**SOUTH CAROLINA BUILDING CODES
STATEWIDE MODIFICATIONS INDEX**

2012 INTERNATIONAL RESIDENTIAL CODE

**SOUTH CAROLINA MODIFICATIONS
TO THE 2012 EDITION OF THE
INTERNATIONAL RESIDENTIAL CODE**

FIGURE 307.2
MINIMUM FIXTURE CLEARANCES

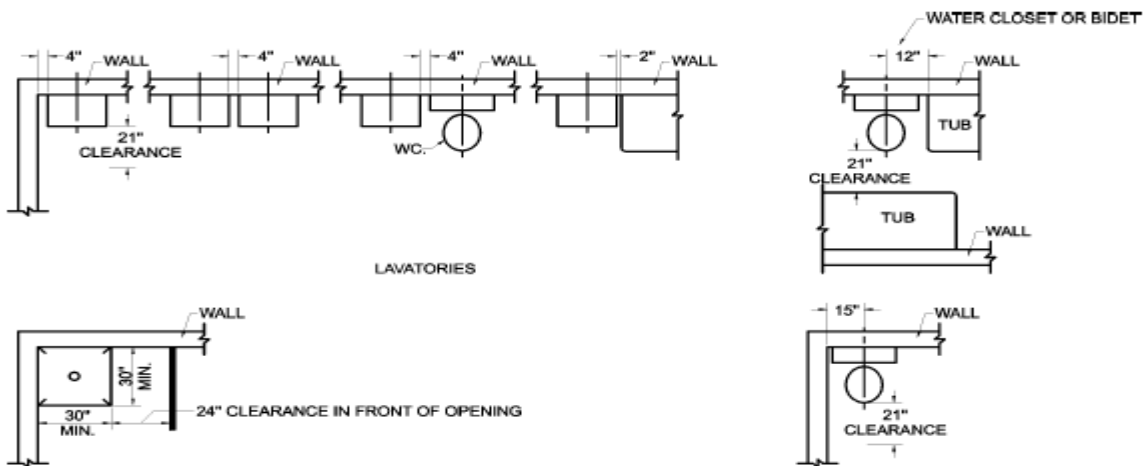
Figure: R307.1 Minimum Fixture Clearances.

Modification: Change the minimum dimension for the side clearance between bathtubs and water closets and bidets from 15 inches to 12 inches.

Reason: No valid reason exists to justify a minimum clearance of 15 inches.

Notes: Continued modification IRC 2003 05 and IRC 2006 06. The Figure number changed from 307.2 to 307.1 in the 2012 IRC.
